Issued by	Introduction from serial No.	Date	Product affected	P/B No
Prashik.V		9/7/2026	EB+ Gen3	0281M

Title / Subject	Reg No.	Edition / Ref. No.	Page
EB+ Gen3 Switch box design update		02	**1** of **2**

EB+ Gen3 switch box design update

Current design | New design

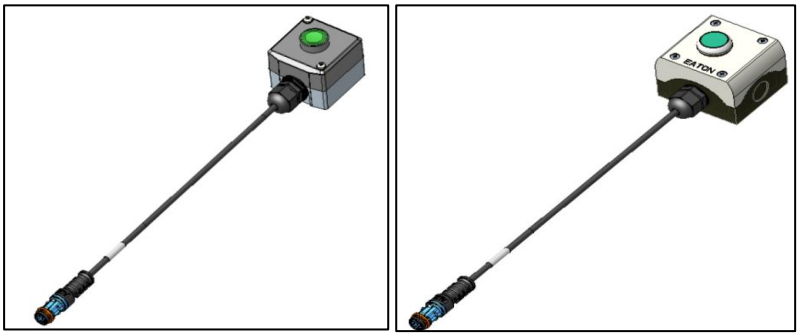
Switch box dimensions have increased from **68 × 68 × 53 mm** to **72 × 80 × 56 mm**.

The revised switch box features an updated housing design together with additional mounting points.

Current design New design

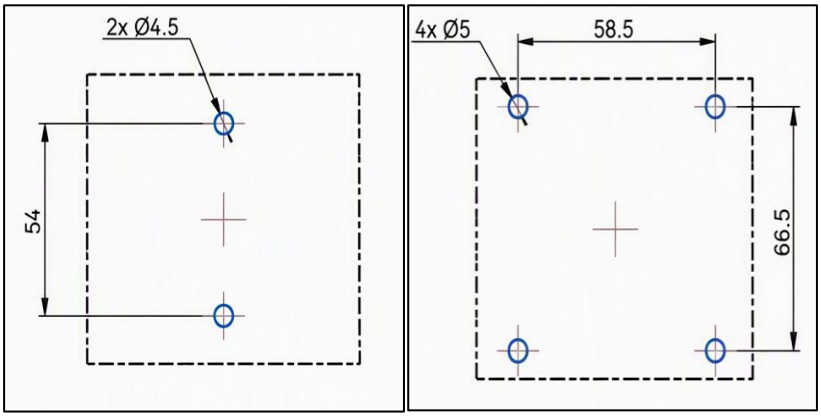
For 815 031 001 (front mounted), mounting hole requirements:

Current design:

- 2 × holes for M4 fixings, spaced 54 mm apart.
- Mounting screws are required but are not supplied.

New design:

- 4 × Ø5 mm mounting holes, spaced 58.5 mm and 66.5 mm apart.
- Mounting screws are required but are not supplied.

Current design New design

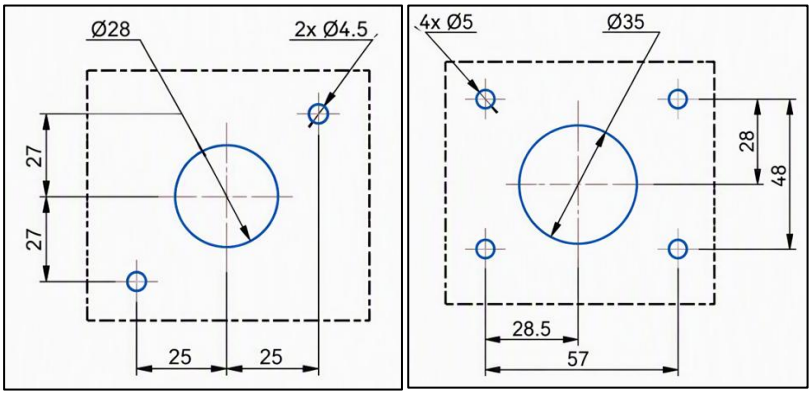
For 815 040 001 (rear mounted) mounting hole requirements:

Current design:

- 1 × Ø28 mm hole for the button.
- 2 × Ø4.4/4.6 mm mounting holes, spaced 50 mm and 54 mm apart.
- The mounting holes are equally spaced around the button.
- Reuse the mounting screws from the box assembly.

New design:

- 1 × Ø35 mm hole for the button.
- 4 × Ø5 mm mounting holes, spaced 48 mm and 57 mm apart.
- The upper-left mounting hole is positioned 28.5 mm and 28 mm from the Ø35 mm buttonhole. The button is not centrally positioned.
- Reuse the mounting screws from the box assembly.
